UNITED STATES PATENT AND TRADEMARK OFFICE

APPLICATION NO.	FILING DATE	FIRST NAMED INVENTOR	ATTORNEY DOCKET NO.	CONFIRMATION NO.
10/605,852	10/30/2003	Martin Weiss	20073	2851
23470	7590	01/05/2006	EXAMINER	
SRAM CORPORATION 1333 N. KINGSBURY, 4TH FLOOR CHICAGO, IL 60622			LUONG, VINH	
			ART UNIT	PAPER NUMBER
			3682

Office Action Summary	Application No.		Applicant(s)	
	10/605,852		WEISS, MARTIN	
	Examiner		Art Unit	
	Vinh T. Luong		3682

Fig. 3

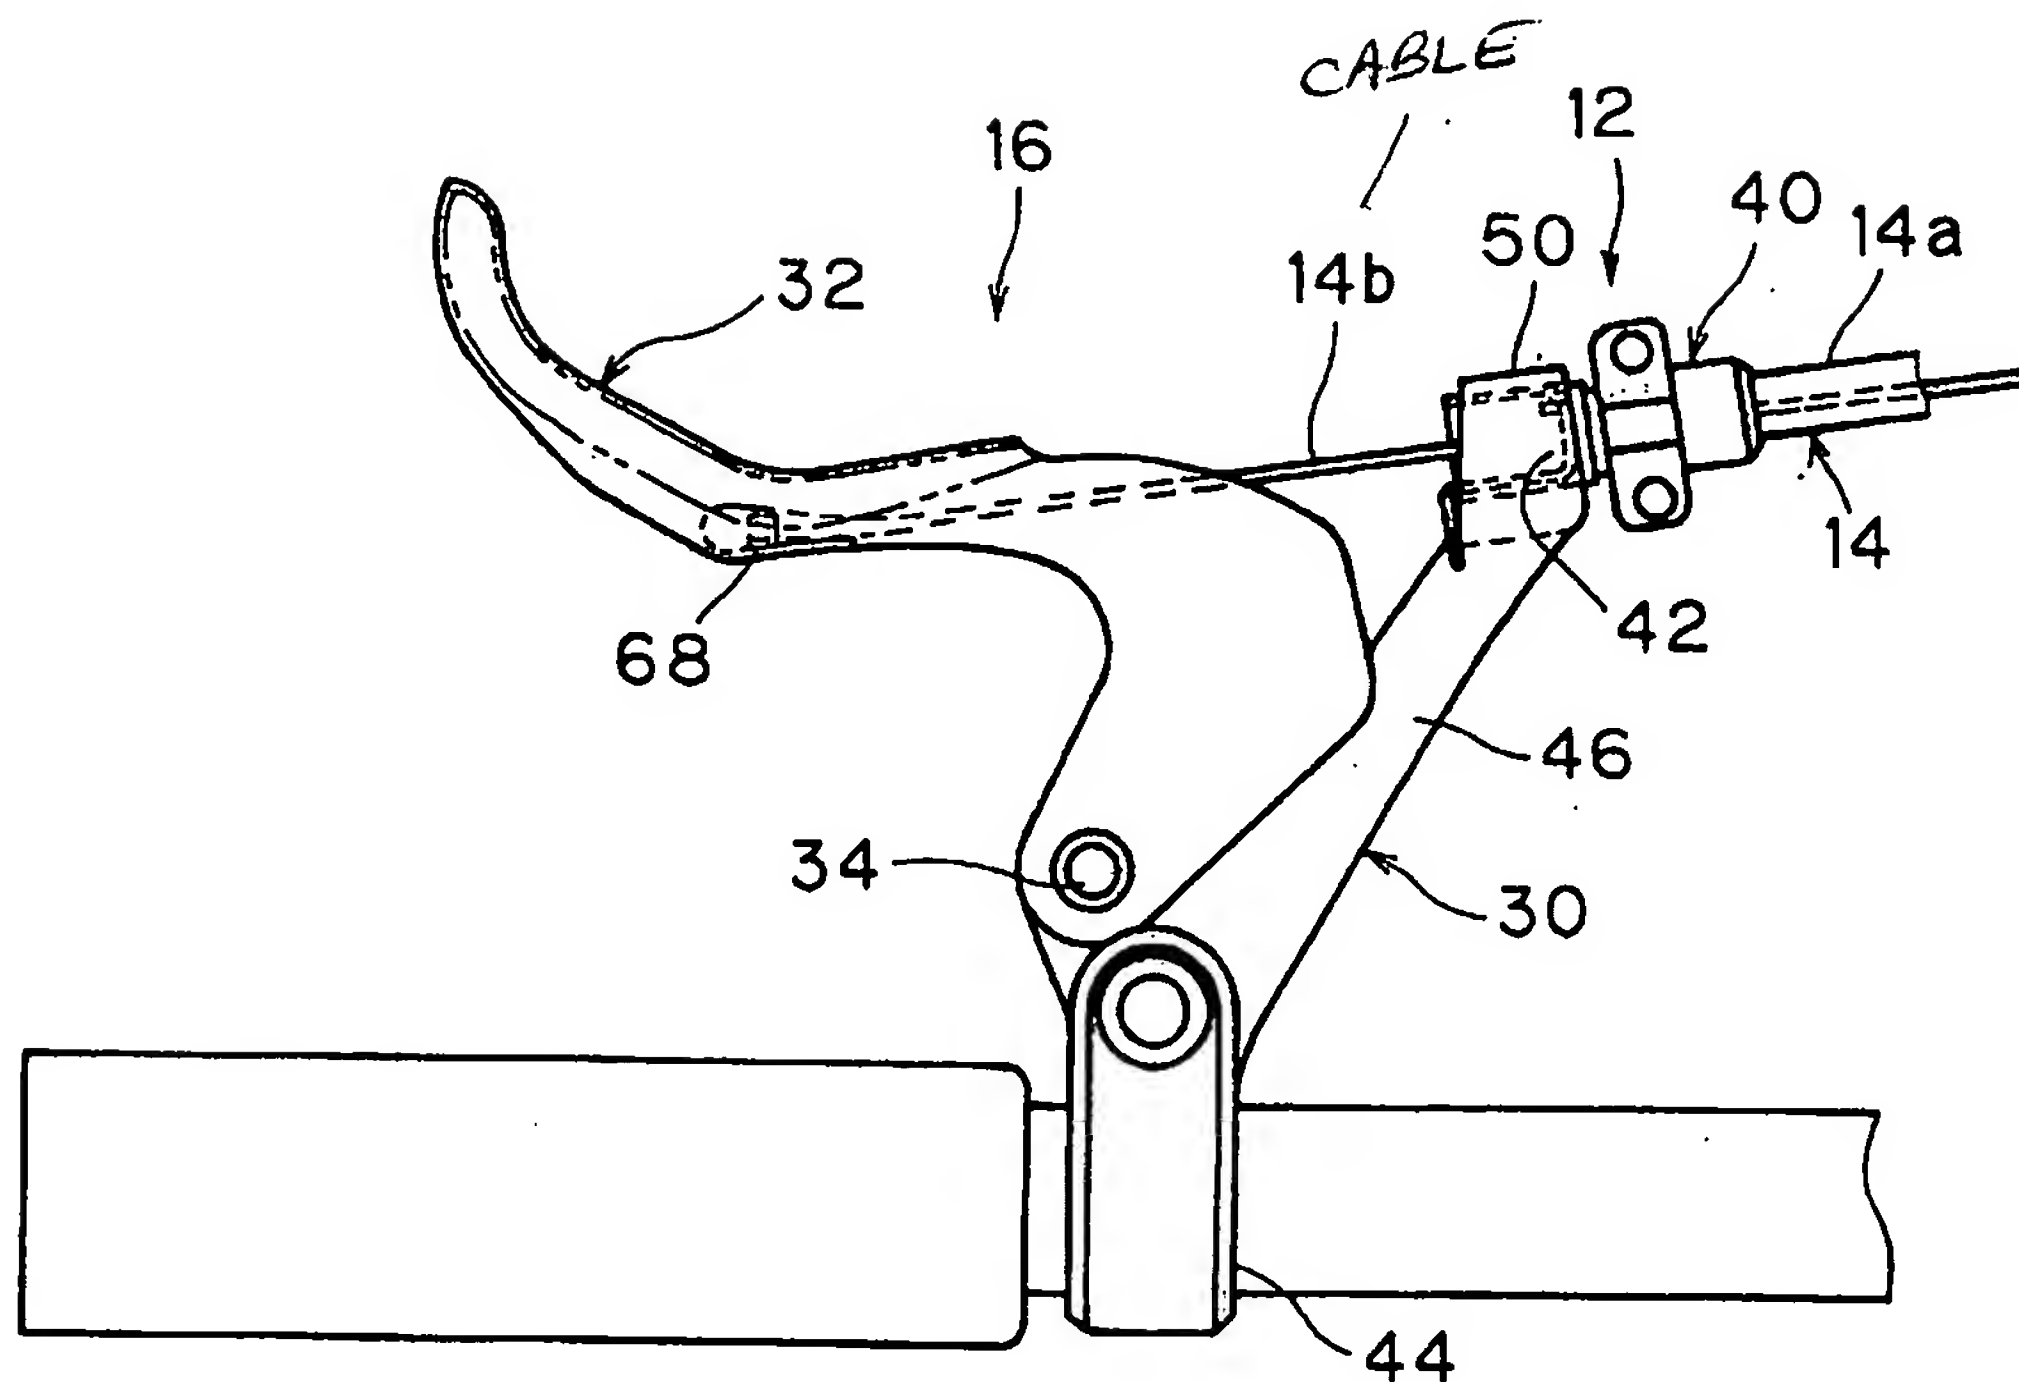
Regarding claim 16, the detent contour 80 has a non-round cross section (Fig. 5) and is configured such that the retention segment 93 has freedom to deflect, the retention segment 93 is configured to extend substantially parallel with a portion of the control cable 14b extending through the adjuster 40. See Fig. 3.

Fig. 4

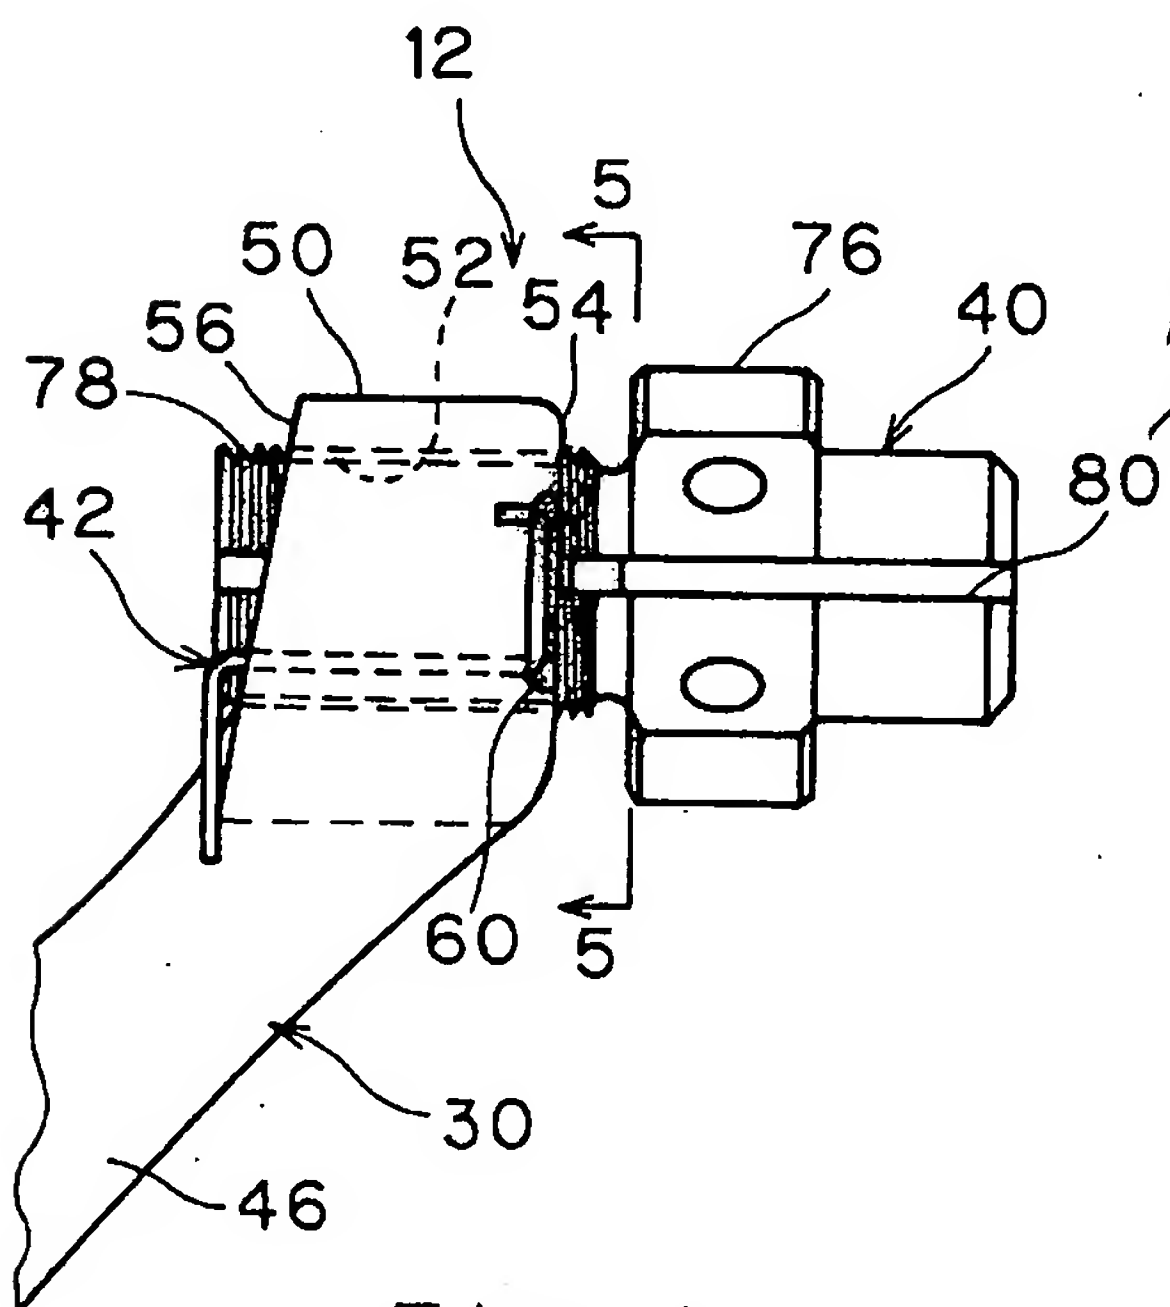
Ibid., Figs. 4 and 5 and col. 5, line 56 through col. 6, line 64.

Fig. 5

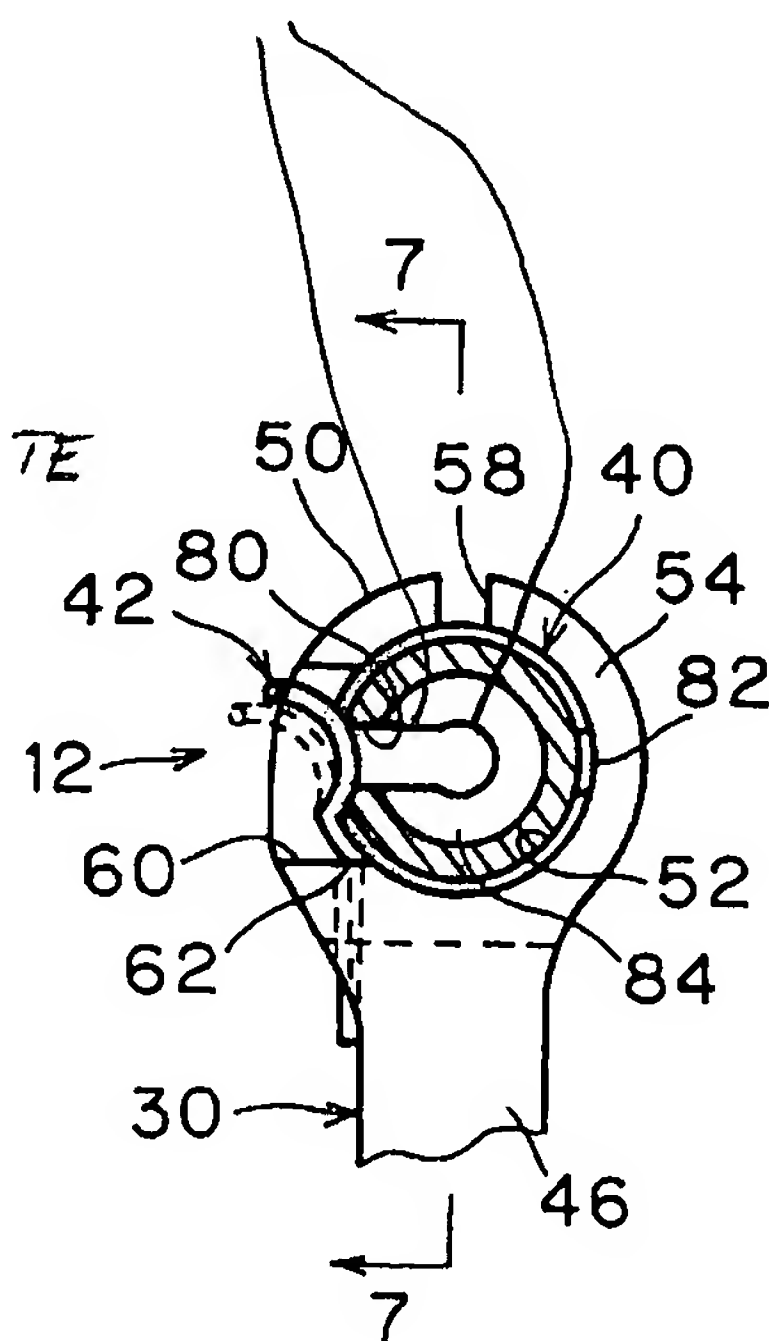
Regarding claim 17, the detent contour 80 includes varying surfaces (Fig. 5, see Attachment) configured to engage the retention segment 93 such that rotation of the adjuster 40 in a first direction requires a higher rotational force than rotation of the adjuster in a second direction. *Ibid.*, col. 6, lines 24-64.

Regarding claim 18, the detent contour 80 has flutes 80 (Att.) extending in an axial direction of the adjuster 40.

VARYING SURFACES

Fig. 7

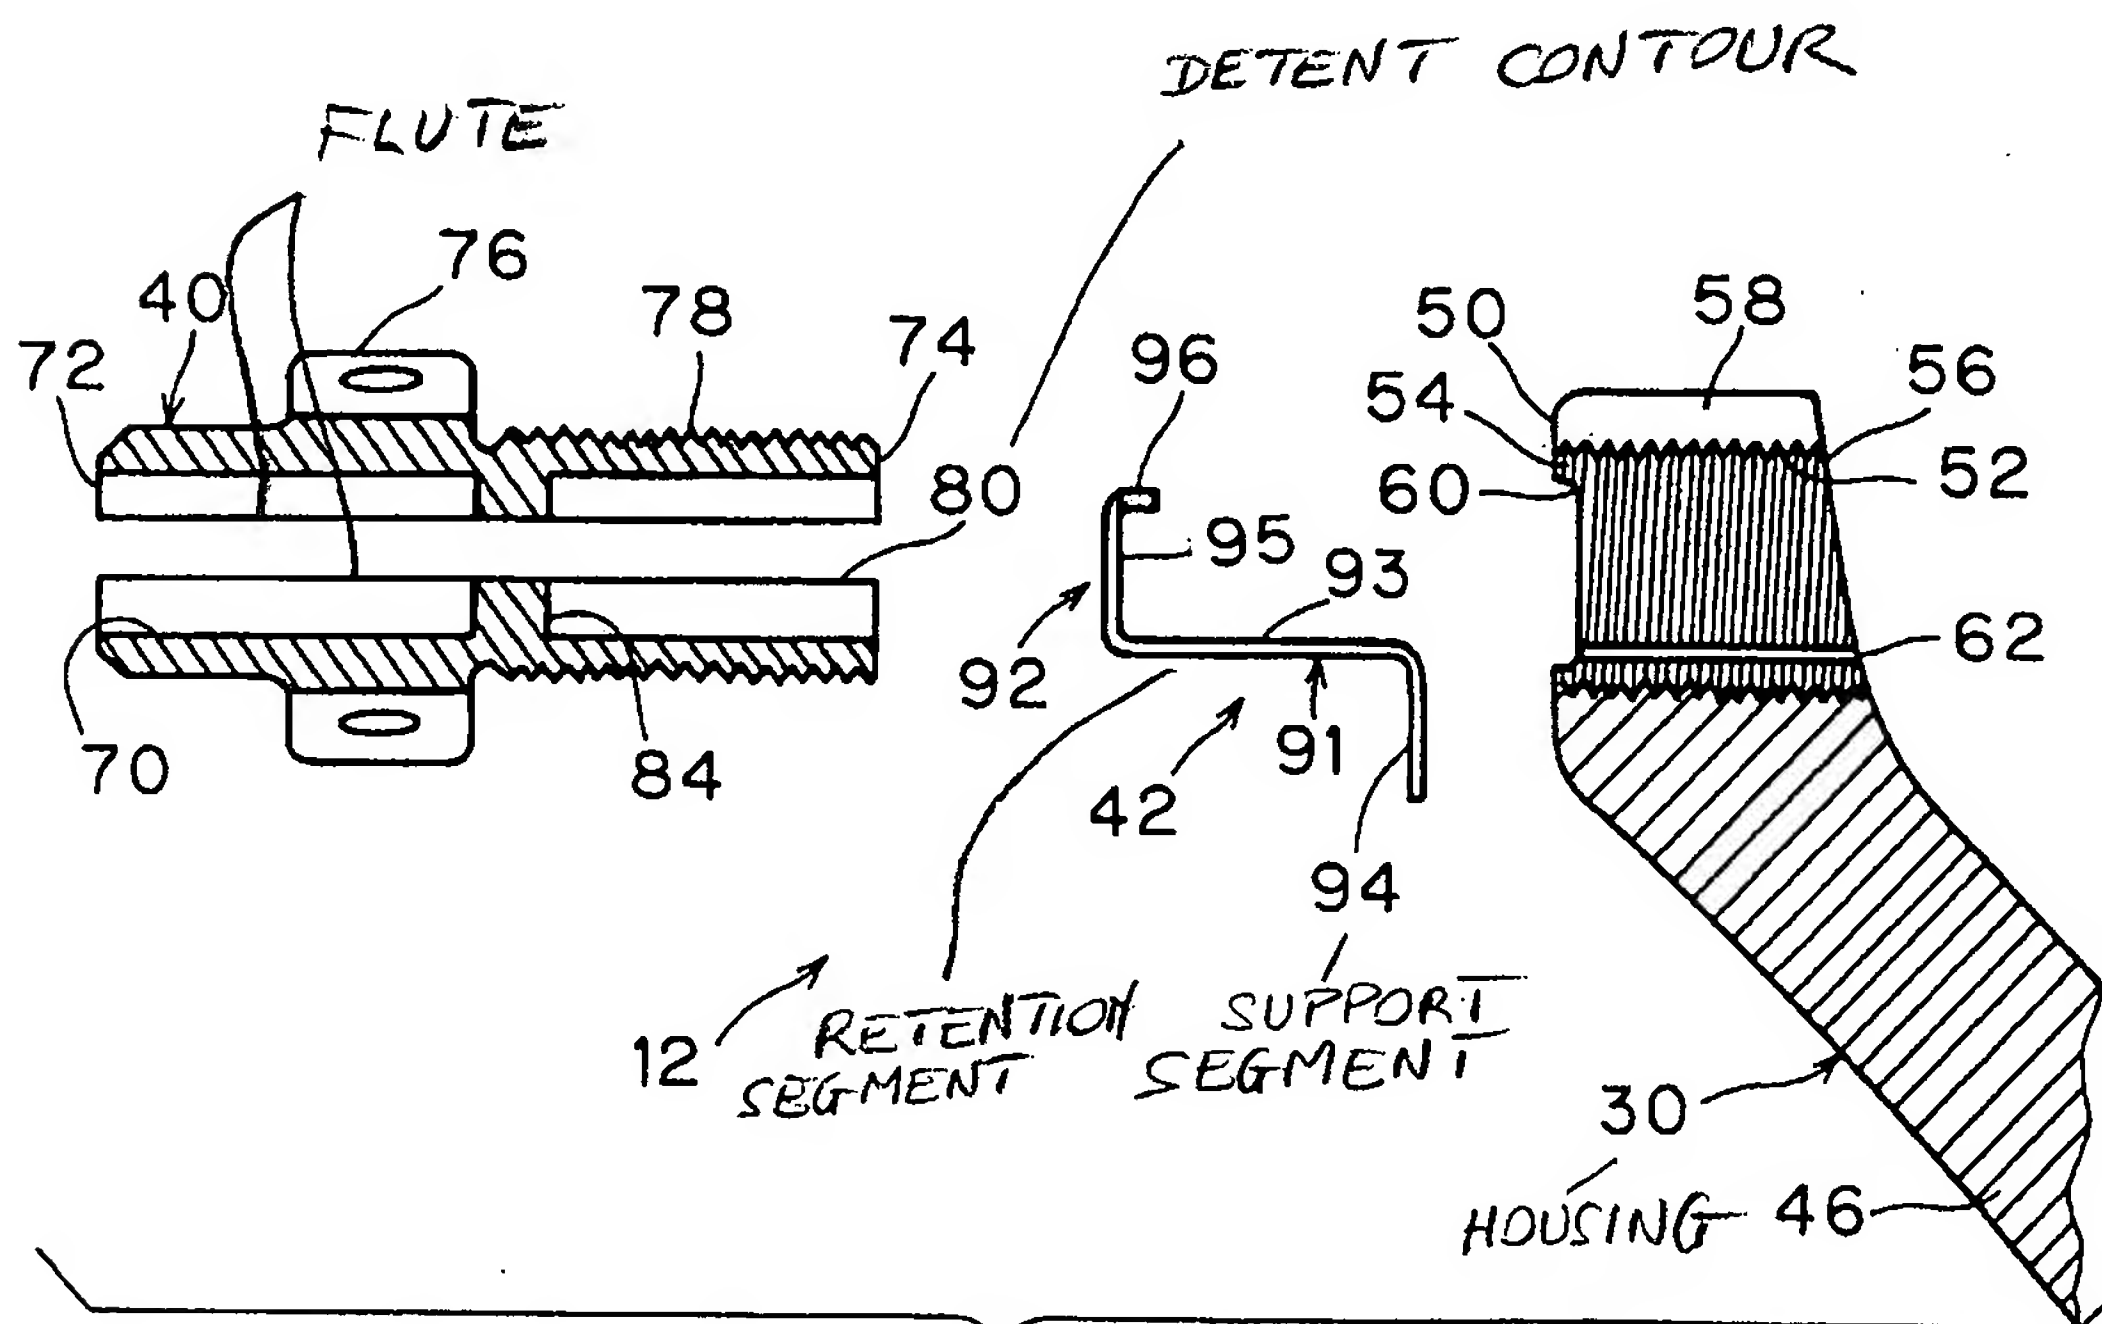
Regarding claim 15, Yamashita teaches a control cable adjustment device for adjusting a control cable 14 extending between a control mechanism 18 (Fig. 1) and an operating mechanism 16, the adjustment device comprising: an adjuster 40 (see, e.g., Fig. 12) rotatably connected to a housing 30 of the operating mechanism 16 such that the adjuster 40 is axially movable relative to the housing 30 in response to rotation of the adjuster 40; and a detent mechanism including a detent contour 80 extending along an interior surface (Fig. 7) of the adjuster 40 and a spring element 42 having at least one retention segment 93 and a support
